TRANSMITTAL OF THE REPLACEMENT PAGES AND COMMENT RESPONSE SUMMARY FOR THE SITE EVALUATION REPORT FOR ADDENDUM 2 SOIL PILES AT THE PADUCAH GASEOUS DIFFUSION PLANT, PADUCAH, KENTUCKY (DOE/LX/07-0188&D2/R1)

**Site Evaluation Report
for Addendum 2 Soil Piles
at the Paducah Gaseous Diffusion Plant,
Paducah, Kentucky
DOE/LX/07-0188&D2/R1, issued January 2010**

COMMENT RESPONSE SUMMARY
for the
Site Evaluation Report for Addendum 2 Soil Piles at the Paducah Gaseous Diffusion Plant, Paducah, Kentucky
DOE/LX/07-0188&D2/R1

Figure B.30. Comparison between Uranium-238 Concentrations in Samples from Soil Piles Addendum 2 and Surface Soil Background Concentrations

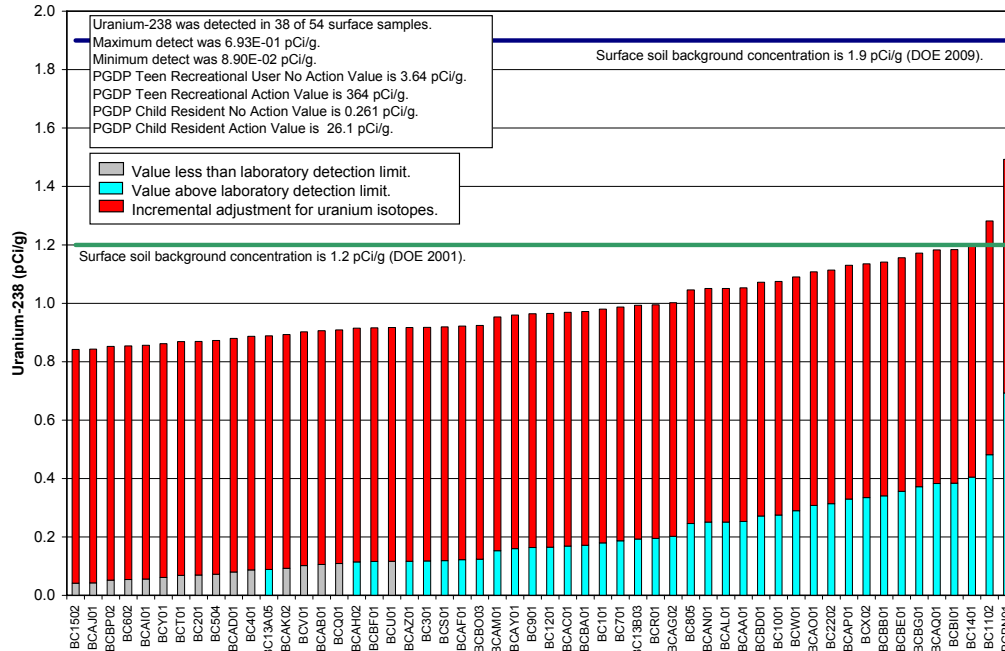
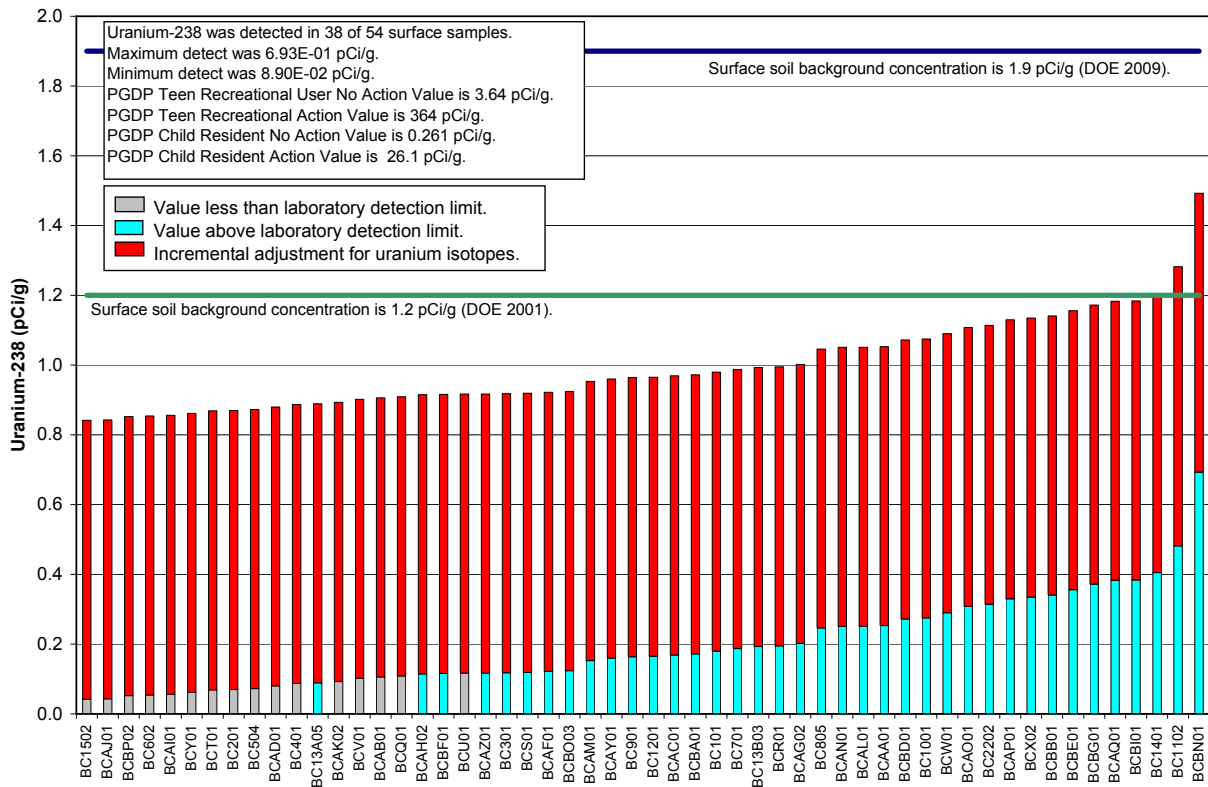
2.		Figures B.30 and B.32 should be revised so as to be consistent with the language of the Uranium Data White Paper, specifically, the incremental adjustments from the data should be removed and the adjusted background lines should be corrected on the graphs. The draft 2009 background values should not appear on the graphs.	The following text has been added to page B-63: “Although 3 of 54 results exceed background of 1.2 pCi/g, these results, although uncertain, are well below the recreational no-action level of 3.64.” The following text has been added to page B-67: “Although 2 of 56 results exceed background of 1.2 pCi/g, these results, although uncertain, are well below the recreational no-action level of 3.64.”

4. Appendix B, page B-63 – Removed text “The revised background value, which is derived using two times the log-transformed mean, is 1.9 pCi/g (DOE 2009). Comparing the surface uranium-238 values to the adjusted, revised background value, there are no surface soil samples exceeding background.”
Added text “Although 3 of 54 results exceed background of 1.2 pCi/g, these results, although uncertain, are well below the recreational no-action level of 3.64.”

Uranium-238–Surface. Due to the method by which uranium isotopes were analyzed by the laboratory,² an incremental adjustment was applied in order to compare these results with screening values.² Incrementally adjusted uranium-238 values in surface soil samples exceed the background value of 1.2 pCi/g (1.205, 1.282, and 1.493) in three of the 54 samples. The exceeding values are the following: 0.405, 0.482, and 0.693 pCi/g. Prior to the incremental adjustment, uranium-238 values in surface soil samples did not exceed background. Although 3 of 54 results exceed background of 1.2 pCi/g, these results, although uncertain, are well below the recreational no-action level of 3.64,

Deleted: The revised background value, which is derived using two times the log-transformed mean, is 1.9 pCi/g (DOE 2009). Comparing the surface uranium-238 values to the adjusted, revised background value, there are no surface soil samples exceeding background.
